**FILE**      **NH000-0003-03(053), CLARKE COUNTY**  
SR 10 Loop/Atlanta Highway Interchange.  
P.I. No. 122890

**SUBJECT**   **REVISED PROJECT CONCEPT REPORT**

**REVISED PROJECT CONCEPT REPORT**

DRAWING NO. 5-01

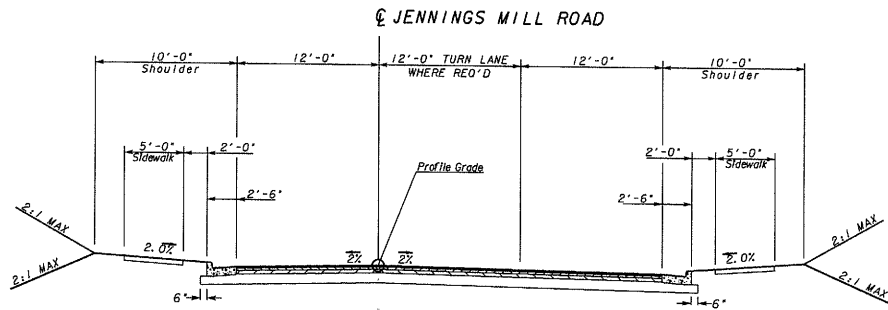
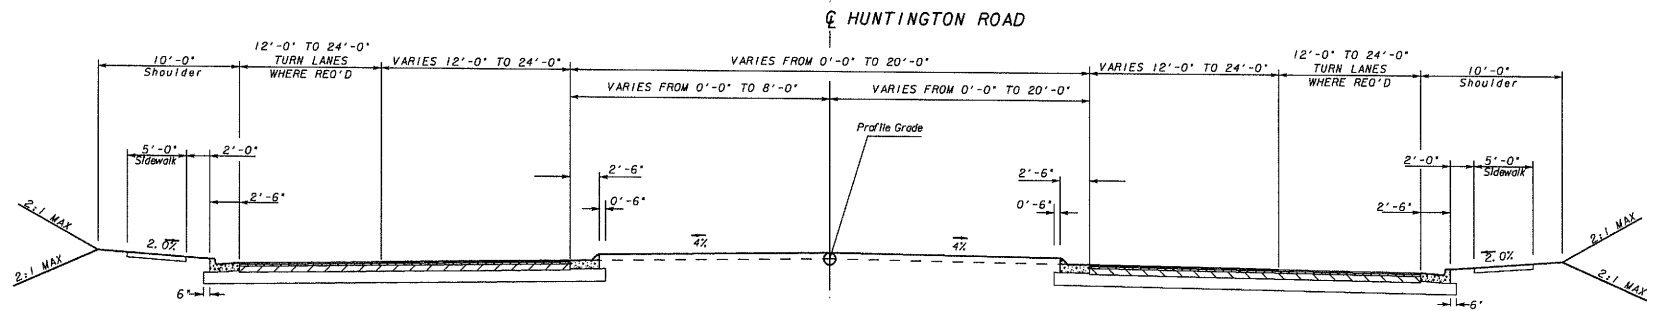
Typical Sections: The typical section for Atlanta Highway is to be revised to remove 4 ft bike lanes and reduce the lane widths to 11 ft. The typical section for Huntington Road, Jennings Mill Road and all minor side road will be revised to have 10 ft urban shoulders. These were recommendations from the approved Value Engineering Study for this project.

- A typical section that includes eleven foot lanes and removes bikes lanes for SR 10/US 78 (Atlanta Highway).
- Typical sections that include ten foot wide shoulders along Huntington Road, Jennings Mill Road and all minor side roads.
